**From:** [Ryan Gregory](#)  
**To:** [Ringel, Matthew](#)  
**Cc:** [Kevin Teague](#); [Richard Mendelson](#)  
**Subject:** Vineyard House Winery - Public Comment  
**Date:** Wednesday, August 27, 2025 4:03:49 PM  
**Attachments:** [250825 Entry Road REVS.pdf](#)

Hi Matthew. I am writing about some neighbor concerns (I am working for Bill Harlan) on the entry road work for this project. We have some suggestions to minimize environmental impacts per NC 18.108.010 and achieve similar practical effect. These are shown on the attached PDF. We have run these by the Applicant's engineer and he is agreeable to make the changes.

DRIVEWAY PLAN  
STA 10+00 TO STA 15+50  
SCALE: 1" = 20'

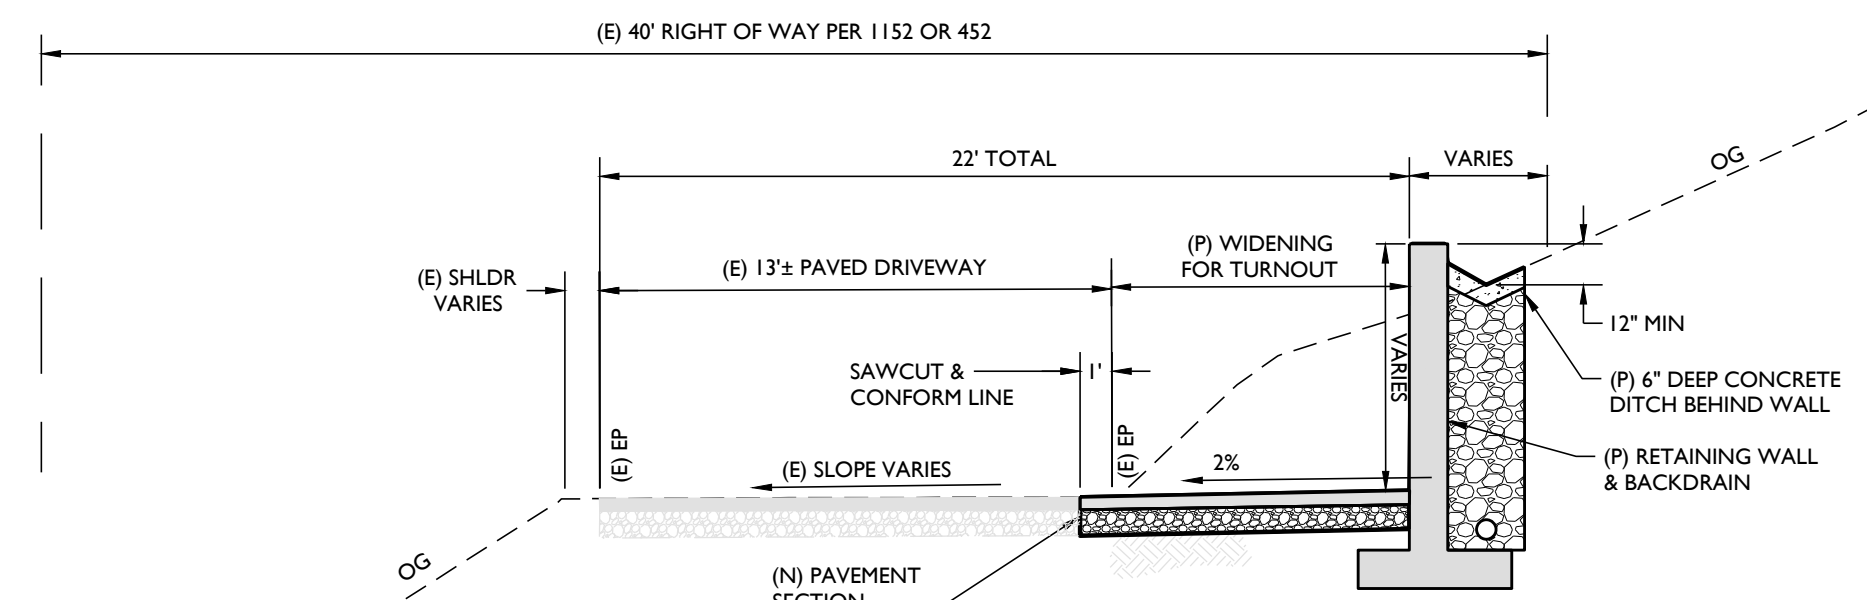
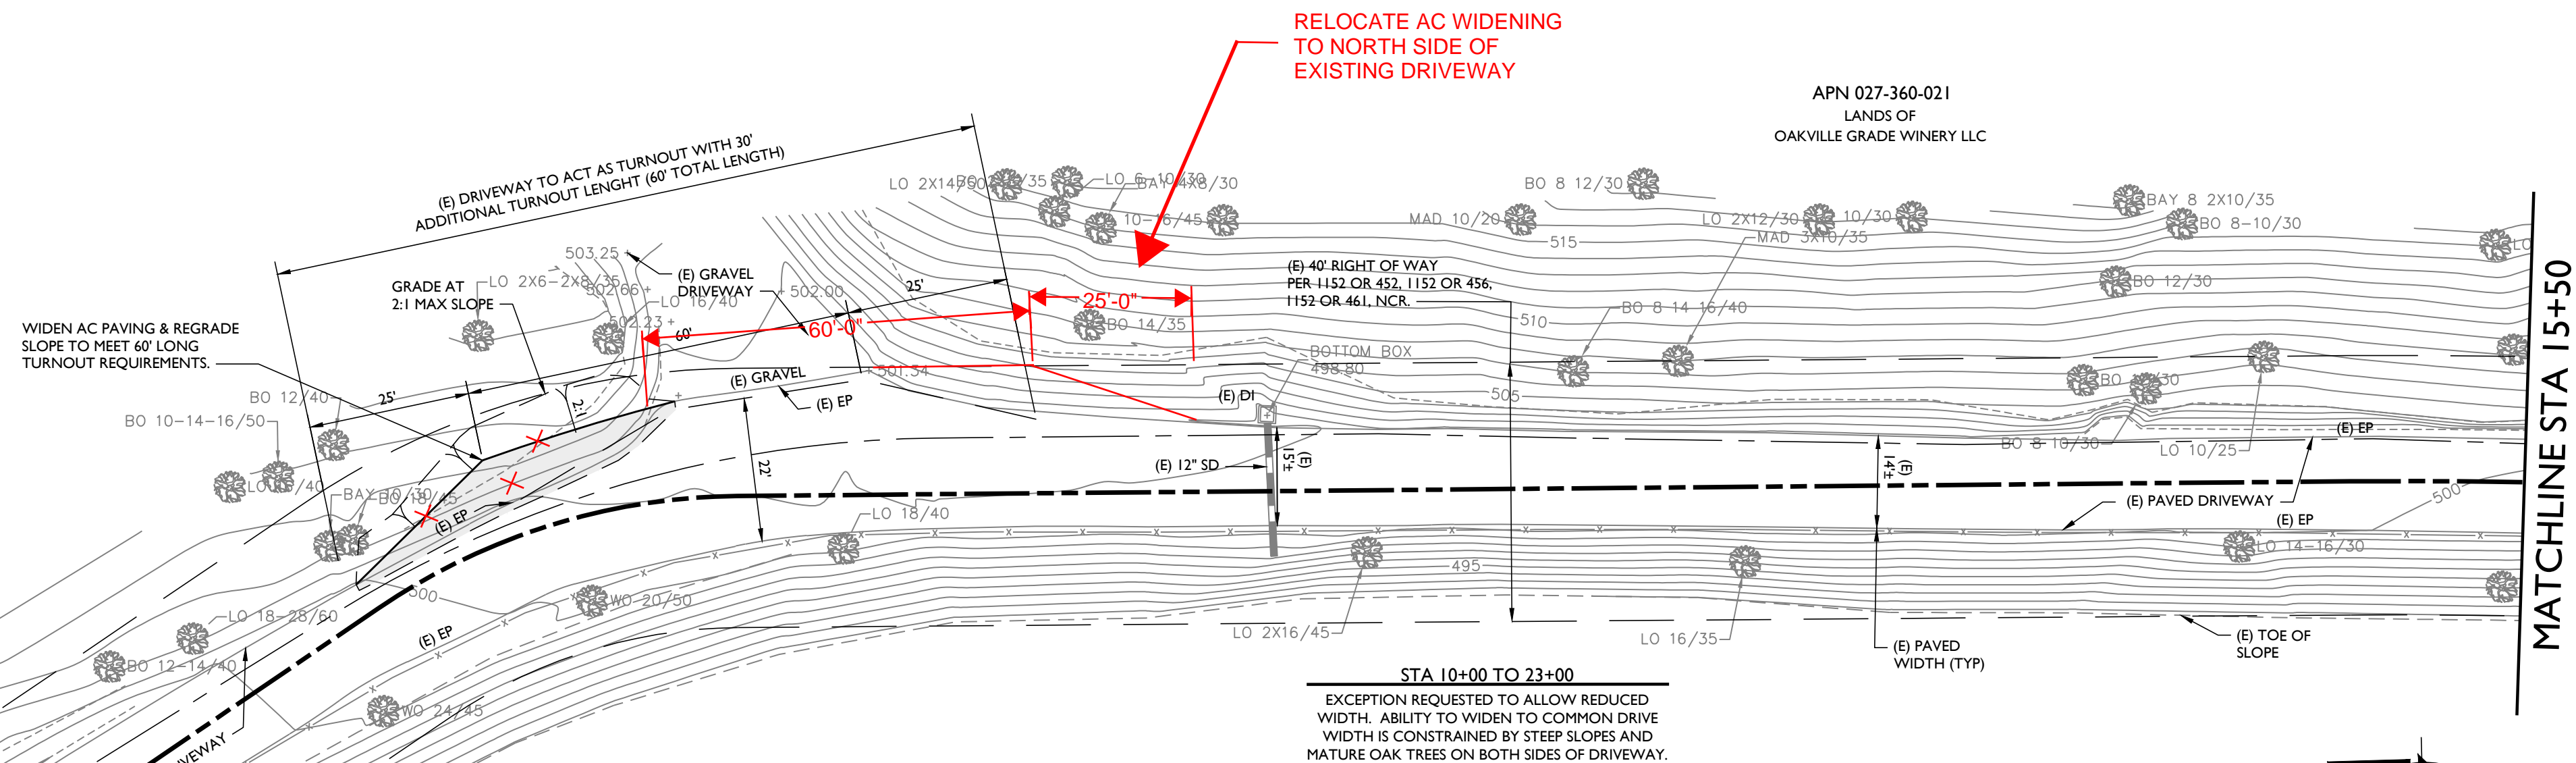
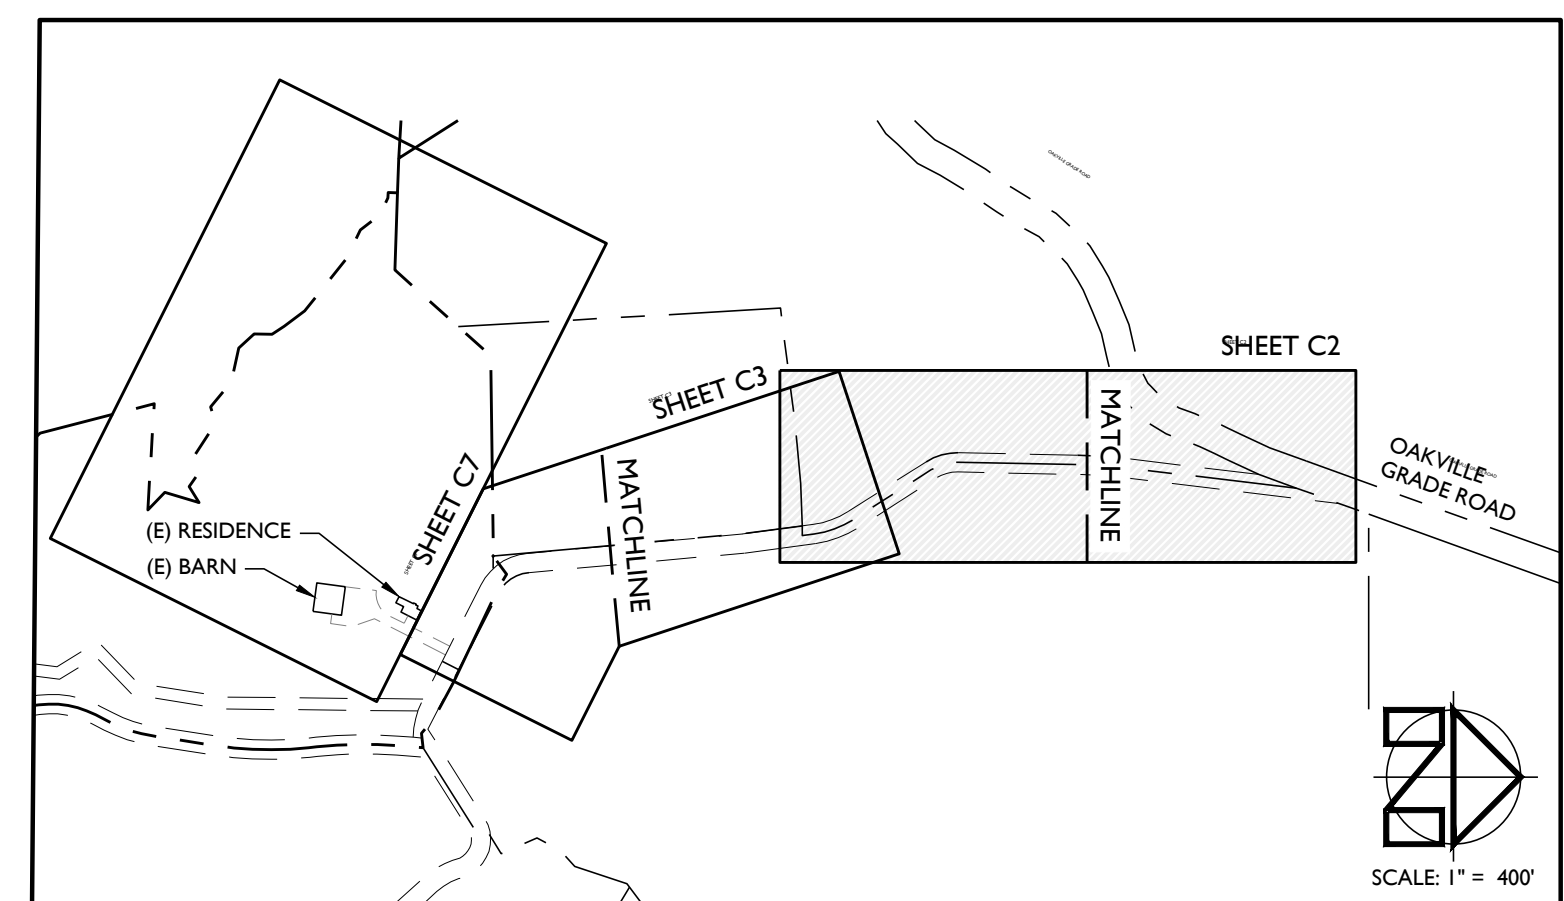
We are hoping this can be presented as a viable alternative to the Planning Commission on Sept 3, and can be recommended as a condition of approval so long as staff determines it to be feasible during building permit/engineering plan check.
